CUP APPEAL: 706 WILLIAMSON ST

SEPTEMBER 16TH, 2014

LEGISTAR FILE IDS: #34335, #34903

Project Address: 706 Williamson Street
Application Type: Demolition and Conditional Use
Legistar File ID #: [34335](#)
Prepared By: Heather Stouder, AICP, Planning Division
Reviewed By: Katherine Cornwell, AICP, Planning Division Director
Report Includes Comments from other City Agencies, as noted

LEVEL ONE PLAN

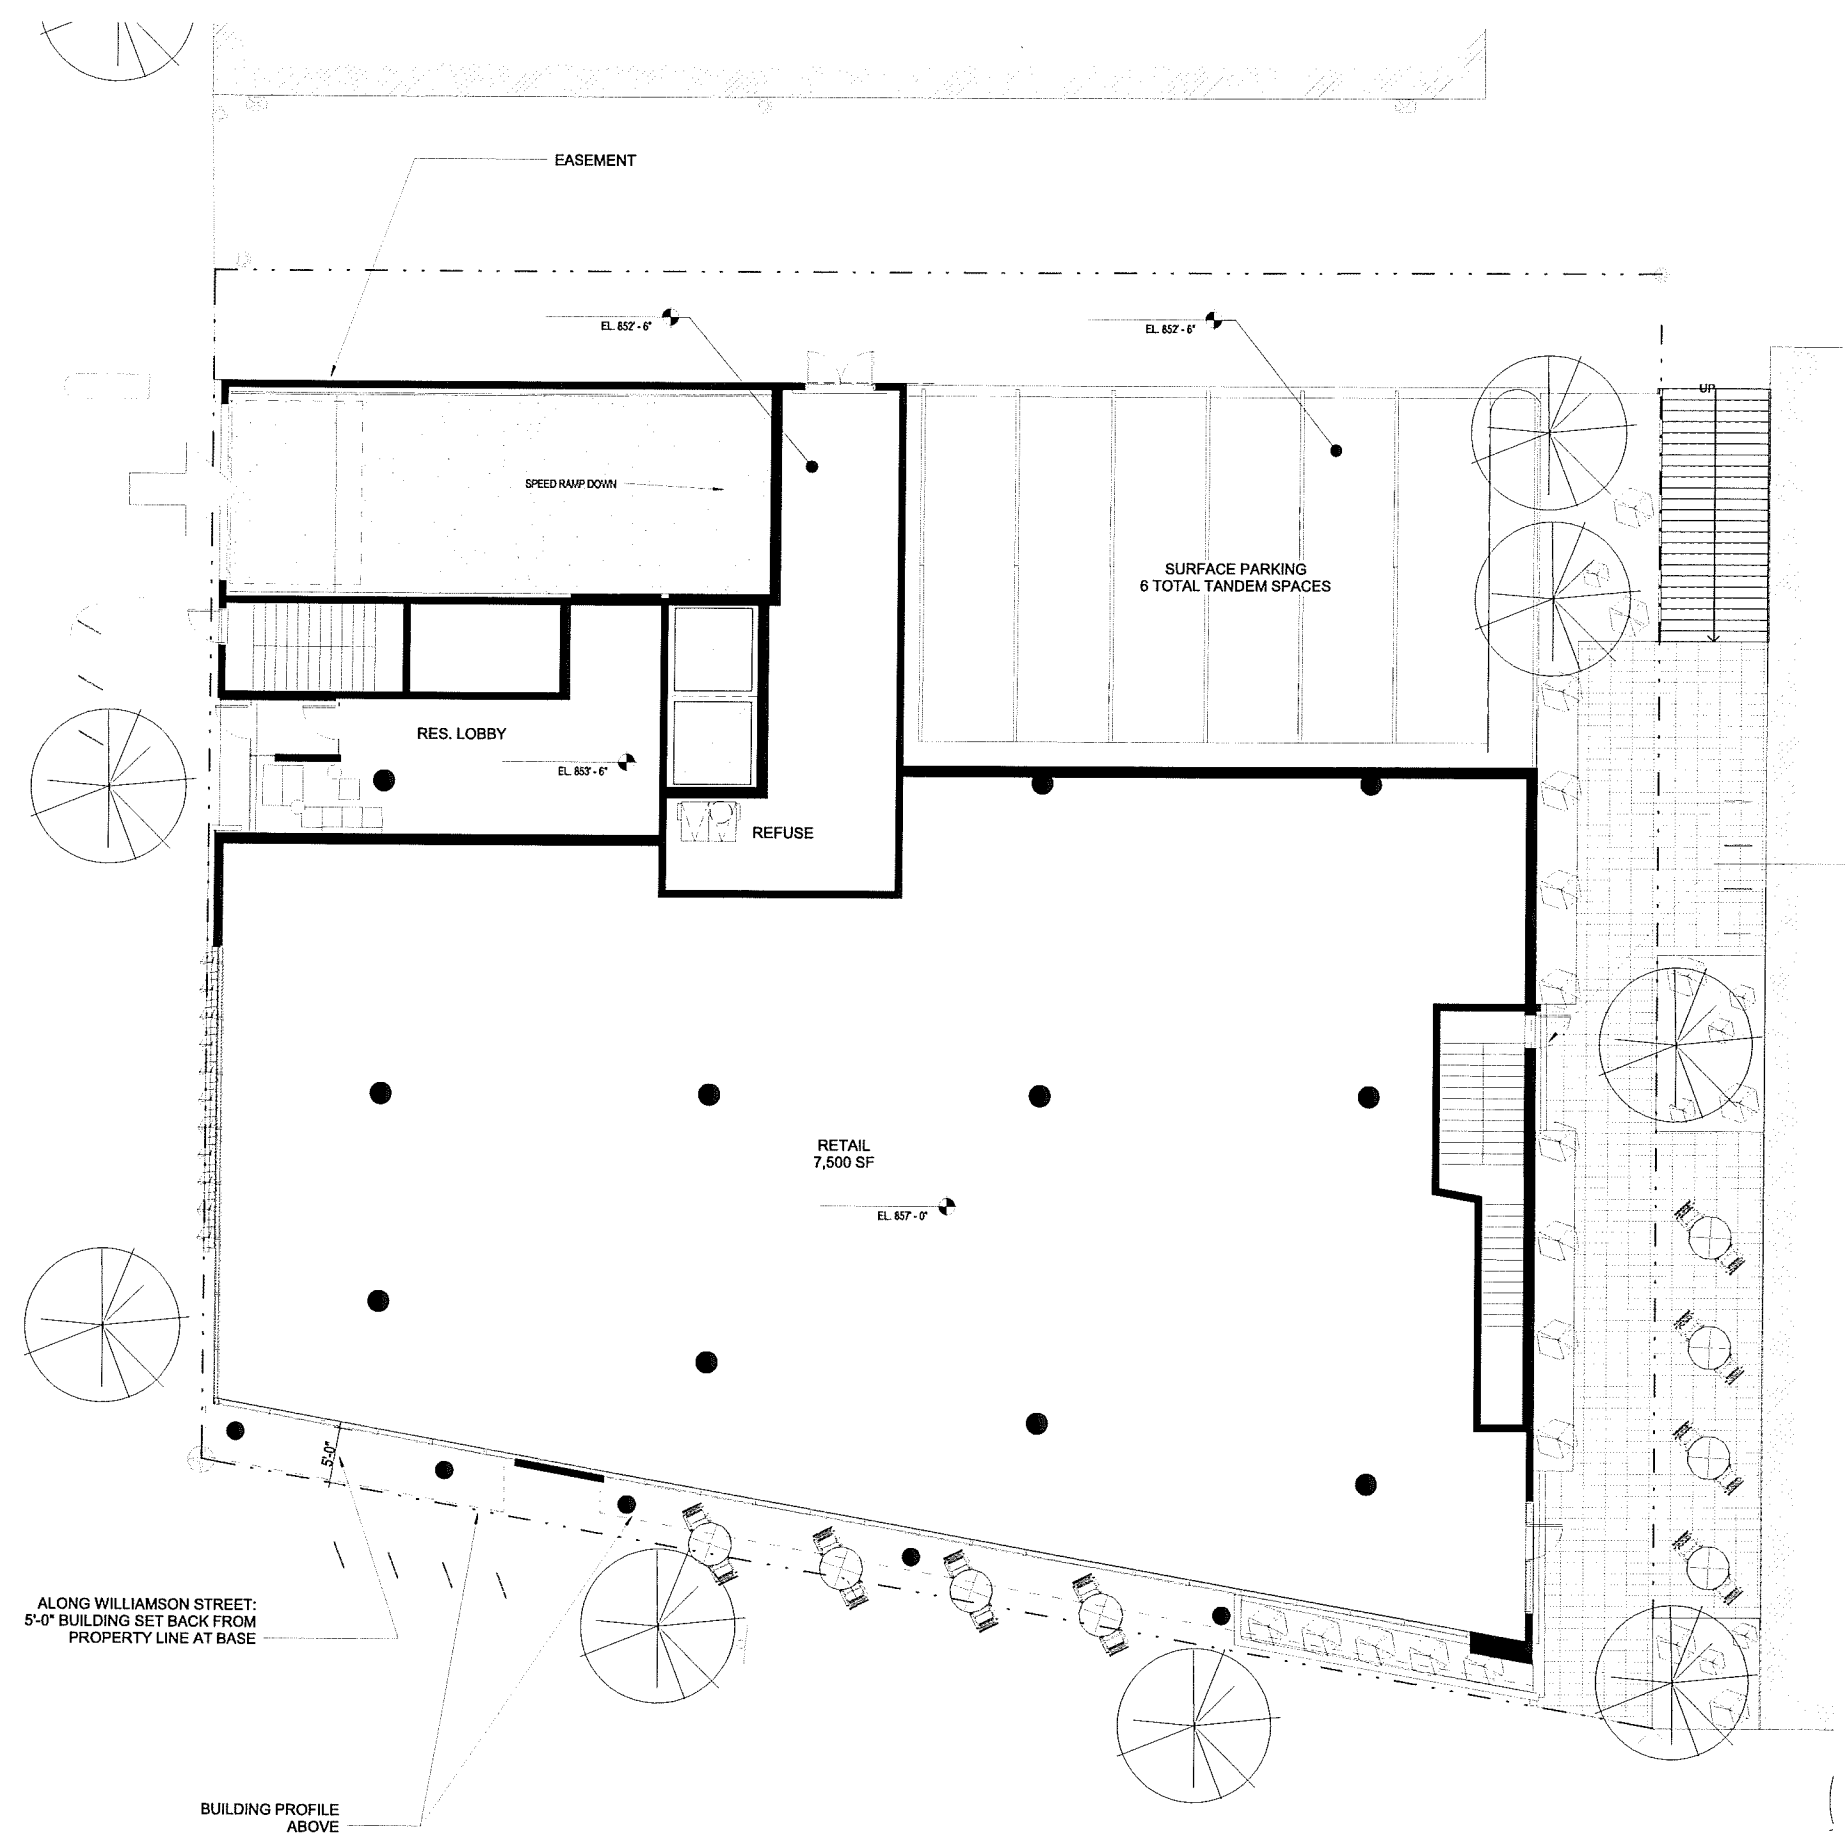
<p>MGO 28.183(6)(a)7: <i>“The conditional use conforms to all applicable regulations of the district in which it is located.”</i></p>	<p>No Findings Made</p>	<p>MGO 28.060(2)(a): <i>“All new buildings shall have a functional entrance oriented to an abutting public street... Entries shall be clearly visible and identifiable from the street...”</i></p> <p>MGO 28.060(2)(b)3: <i>“Division into storefronts, with separated display windows and entrances...”</i></p> <p>MGO 28.060(2)(j): <i>“The base of the building shall relate to the human scale, including doors and windows, texture, projections, awnings, canopies, and similar features...”</i></p> <ul style="list-style-type: none"> •The proposed building's ground floor facade is not articulated. The submitted proposal does not show any commercial entrances or any of the elements related to design of storefronts. The staff report acknowledges that the only commercial entrances shown are from the alley, not from Williamson Street (p. 3)
